**STAFF RECOMMENDATION**  
**1504 Elmwood Avenue**  
**June 20, 2012**

**Application:** Infill and New construction—accessory structure  
**District:** Belmont-Hillsboro Neighborhood Conservation Zoning Overlay  
**Council District:** 18  
**Map and Parcel Number:** 10513011200  
**Applicant:** Rigid Development (Brent Craig)  
**Project Lead:** Melissa Baldock, melissa.baldock@nashville.com

<p><b>Description of Project:</b> Applicant proposes to construct a new one-and-a-half story house and a two-story accessory structure on a vacant lot.</p> <p><b>Recommendation Summary:</b> Staff recommends approval of the construction of the infill building and accessory structure with the conditions that:</p> <ol style="list-style-type: none"> <li>1. The applicant submit new drawings indicating how the grade will be addressed in the new construction, particularly as it relates to the infill’s foundation line and the overall height of the house. (The foundation should have a maximum height of about two feet (2’)).</li> <li>2. Staff approve the house’s asphalt shingle color, final door design, a brick sample, porch floor and stair material, porch railing material, and the porch column shaft m

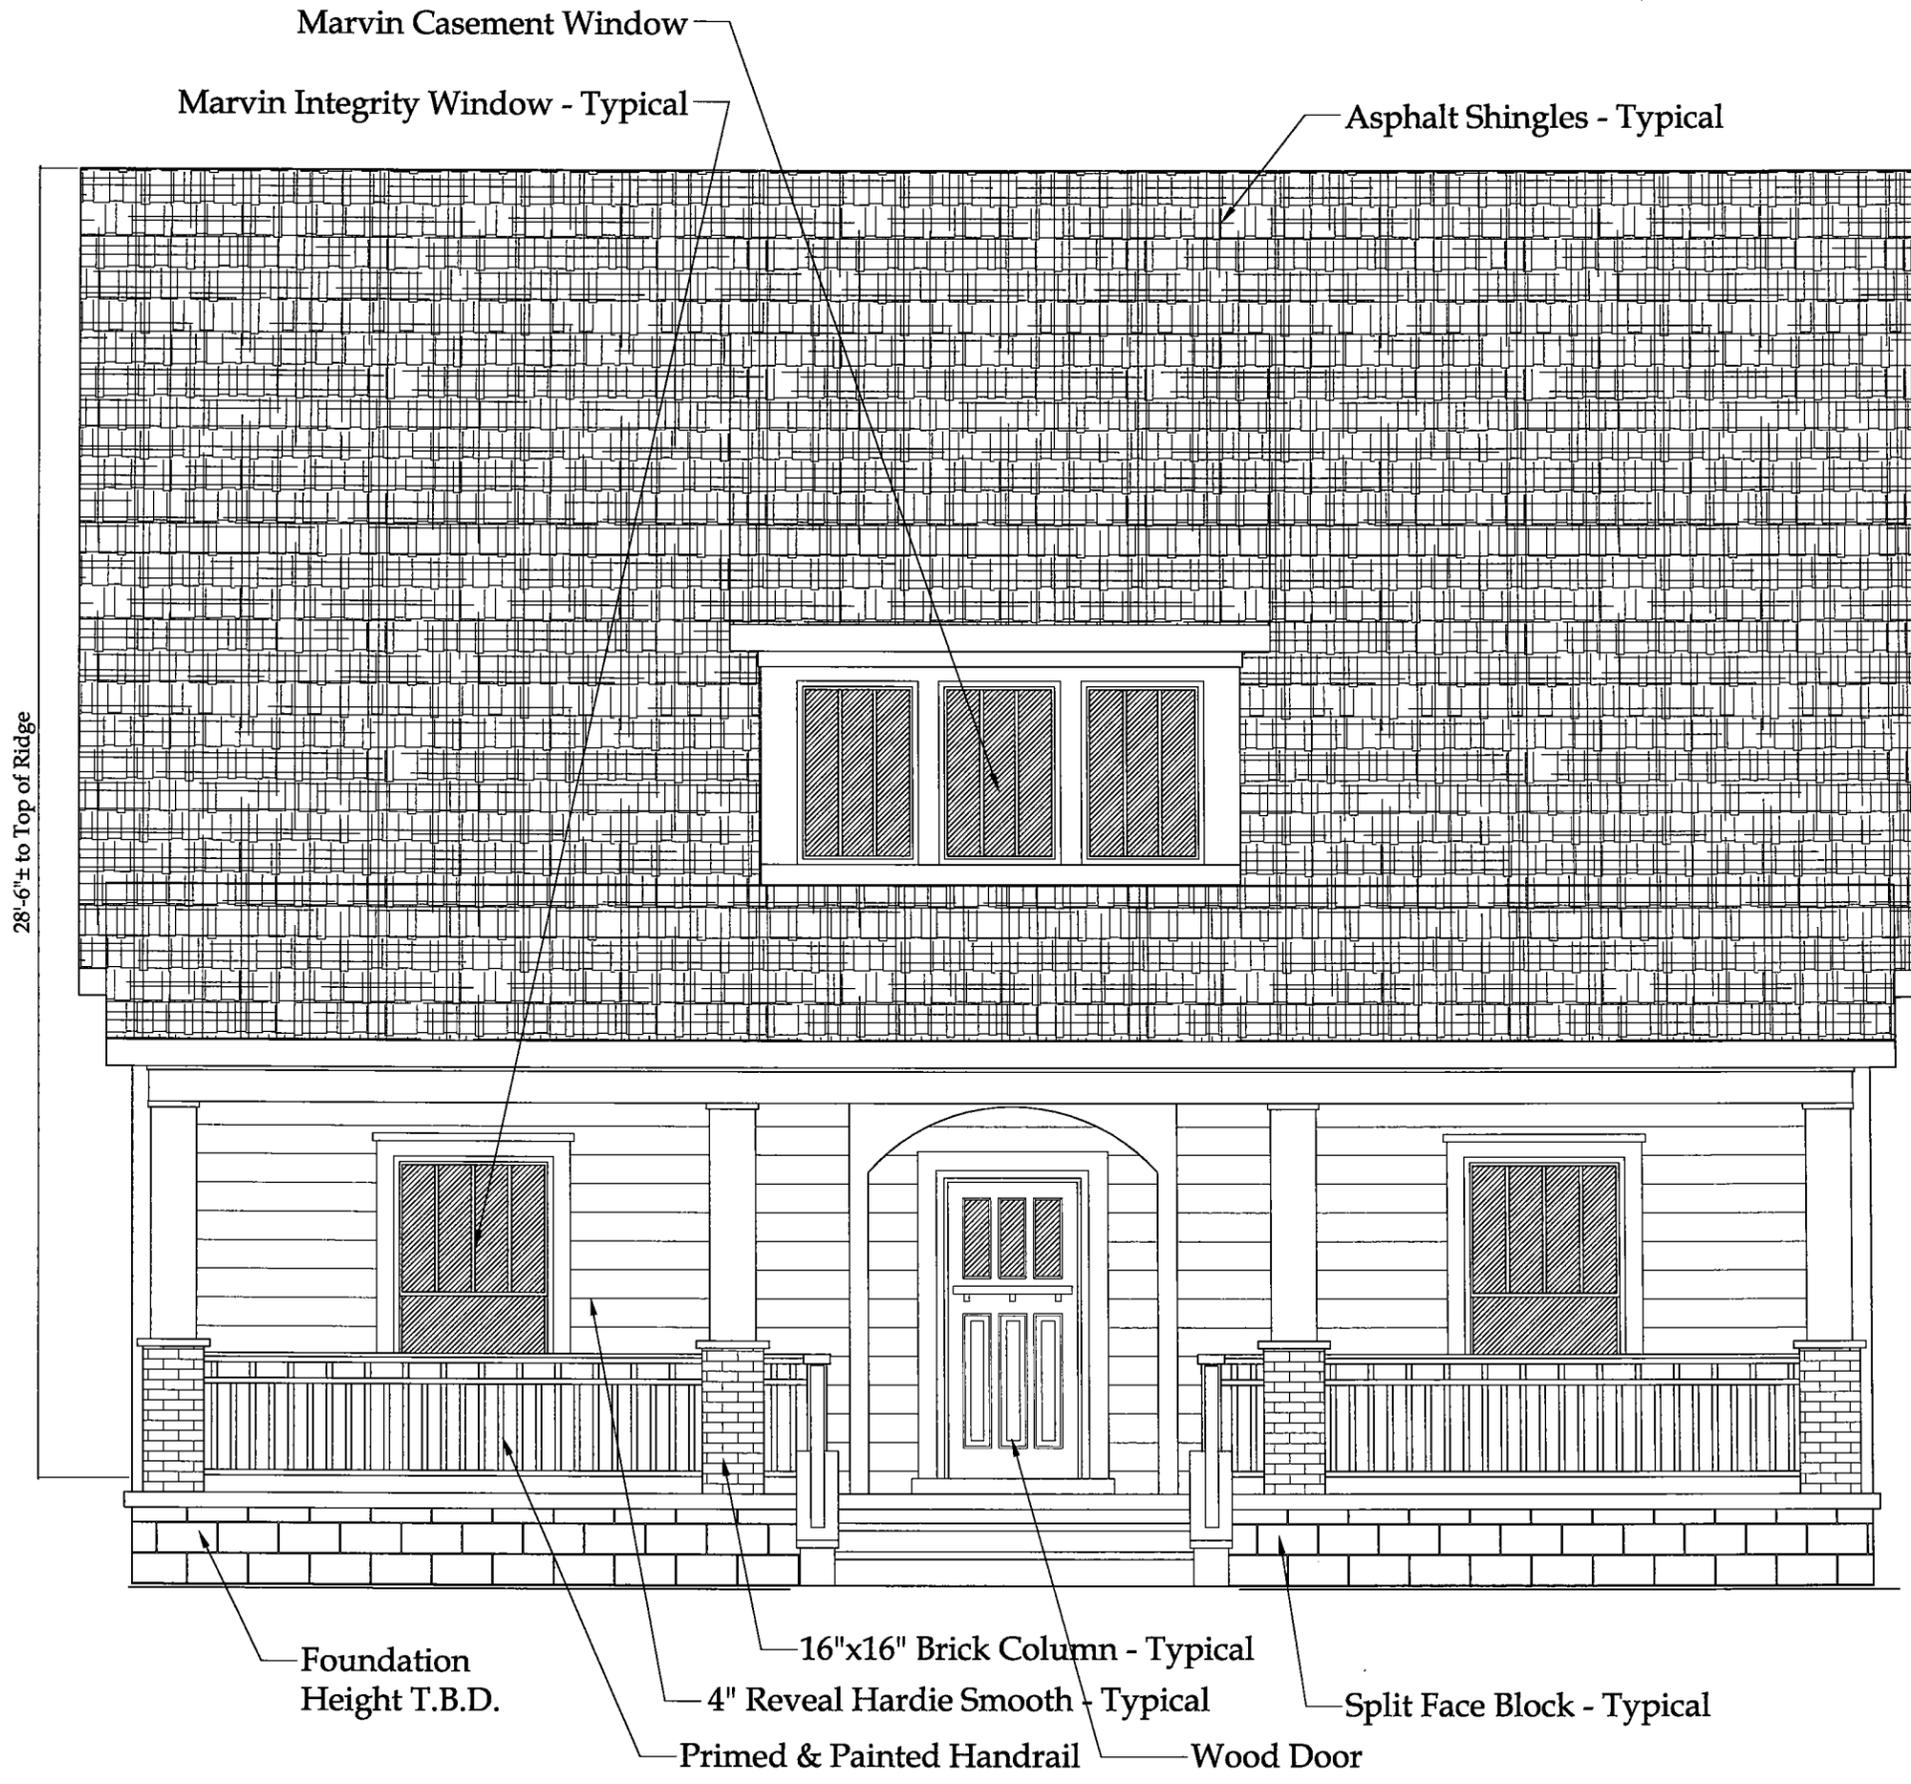
Location and Setback: The proposal meets all bulk zoning setback requirements. The primary building is centered on the lot, similar to other historic buildings found in the district. It will be five feet (5') from the right/east property line, six feet (6') from the left/west property line, and more than seventy-feet (70') from the rear property line. The house's front porch will be approximately thirty-eight feet, nine inches (38'9") from the front property line. Staff finds this front setback to be appropriate because the house to the right (1502 Elmwood) is thirty-four feet, eight inches (34'8") from the front property line, and the house to the left (1506 Elmwood) is forty-one feet, nine inches (41'9") from the front property line.

Orientation: The proposed infill has a full width front porch and centered primary entrance. The infill faces Elmwood Avenue, as do all the other buildings on this block between 15<sup>th</sup> Avenue South and the alley to the west. No walkway was indicated, and staff recommends that a central walkway leading from the sidewalk to the front porch be added to the site. With the addition of a central sidewalk, staff finds the orientation to

3. A central walkway running from the sidewalk to the porch be added.
4. Utilities be located in the rear or on a side façade, beyond the house's midpoint.

Front Elevation

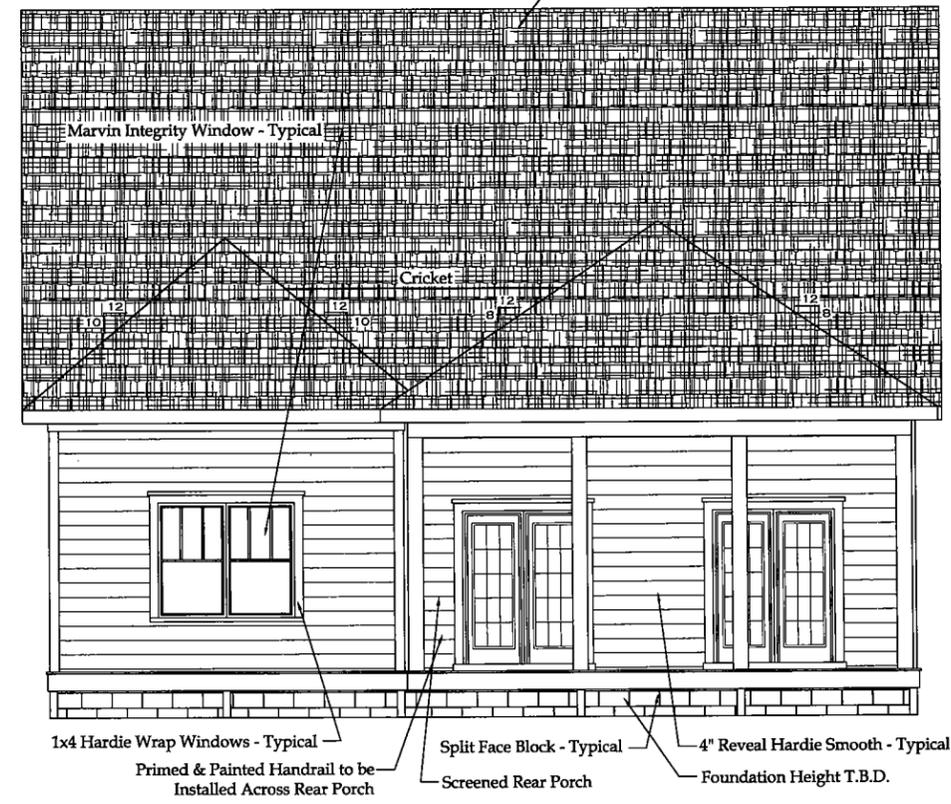
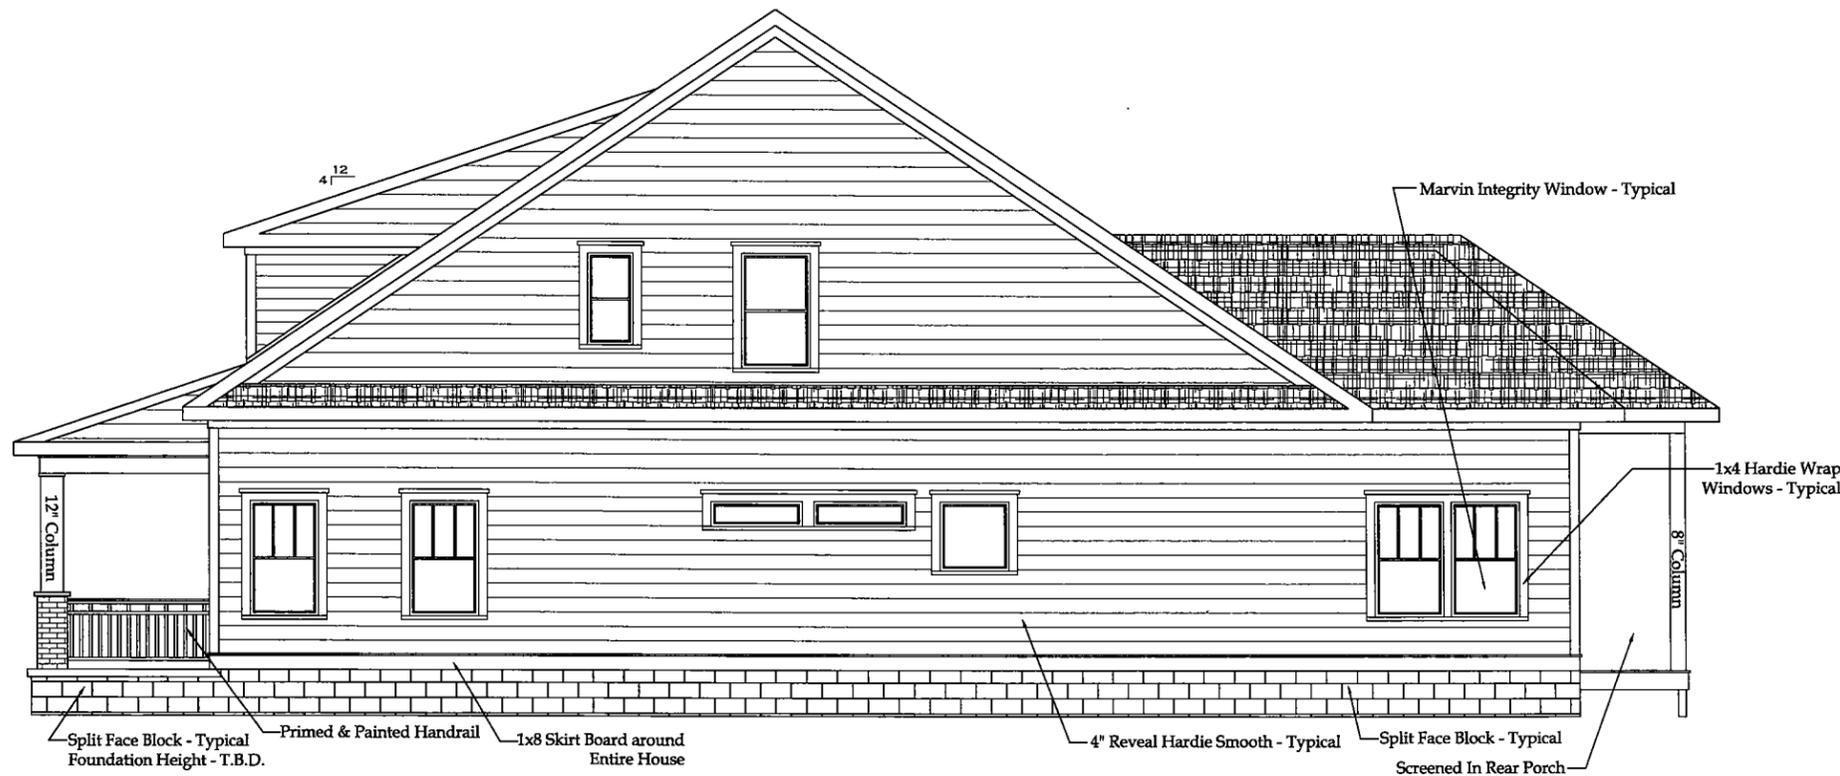
Height & Scale: The proposed structure is drawn to show a maximum height of thirty-one feet (31') from existing grade or twenty-eight feet, nine inches (28'9") above the foundation line. In the immediate vicinity, the heights of historic structures range from eighteen to thirty-five feet (18' – 35'), with the majority of them being in the range of twenty-four to thirty feet (24'-30') tall. The porch eave height is approximately nine feet, three inches (9'3") above the foundation line and the eave height of the main roof is approximately ten feet, nine inches (10'69") above the foundation line.

The drawings do not account for the slope of the lot (see photos below), which likely will not allow for an even foundation line as shown on the drawings. Staff asks that a condition of approval be that the applicant submit new drawings indicating how the grade

will be addressed in the new construction, particularly as it relates to the foundation line. Staff will want to see that foundation height at the front of the house be approximately two feet (2') and that it diminish in height towards the back of the house so that the overall height of the structure is not increased with a taller foundation. With the staff's approval of revised drawings that show the existing grade and the foundation height, staff finds the infill's height, as currently proposed, to be appropriate.

Materials: The primary cladding material will be cement fiberboard with a four inch (4") reveal, which is appropriate. The foundation will be split face concrete block. The roof will be asphalt shingle, and staff asks to approve the roof color prior to purchase and installation of the shingles. The front porch columns will have a brick base, and staff asks to approve a brick sample. The material for the column shaft was not specified and will need to be approved by staff. The materials for the porch floor, steps, and hand rail were also not specified and will need to be approved by staff. The front door is proposed to be wood, which is appropriate, and staff asks to approve the design of the door prior to purchase and installation. The windows will be Marvin Integrity windows, which have been approved in the past for new construction. The rear porch will be screened. The rear porch columns lack a cap and a base, and staff asks that these be added.

Proportion and Rhythm of Openings: The primary windows on the infill are approximately twice as tall as they are wide and so meet the historic ratio of windows in the neighborhood. The largest expanse of wall space without a door or window opening occurs on the rear portion of the right elevation and is approximately fifteen feet (15') in length. Staff finds this expanse to meet the guidelines because it occurs approximately forty-four feet (44') behind the line of the front porch. Staff therefore finds that the window proportions and rhythm of openings meets Section II.B.1.g. of the *Belmont-Hillsboro Neighborhood Conservation Zoning Overlay Handbook and Design Guidelines*.

1. The applicant submit new drawings indicating how the grade will be addressed in the new construction, particularly as it relates to the infill's foundation line and the overall height of the house. (The foundation should have a maximum height of approximately two feet (2')).

2. Staff approve the house's asphalt shingle color, final door design, a brick sample, porch floor and stair material, porch railing material, and the porch column shaft material.
